Appl. No. 10/760,139

Amendments to the Drawings:

REMARKS

FIGURE 3

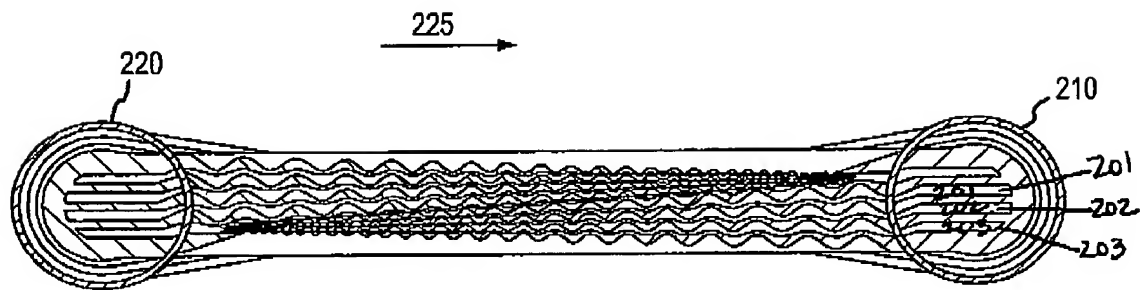
Attached is one annotated drawing sheet showing changes to Fig. 3. Also enclosed are 4 replacement drawing sheets for Figs. 1-4.

Applicants note the Examiner's objection to Figure 3 and has attached a new Figure 3 containing the inadvertently omitted reference numbers.
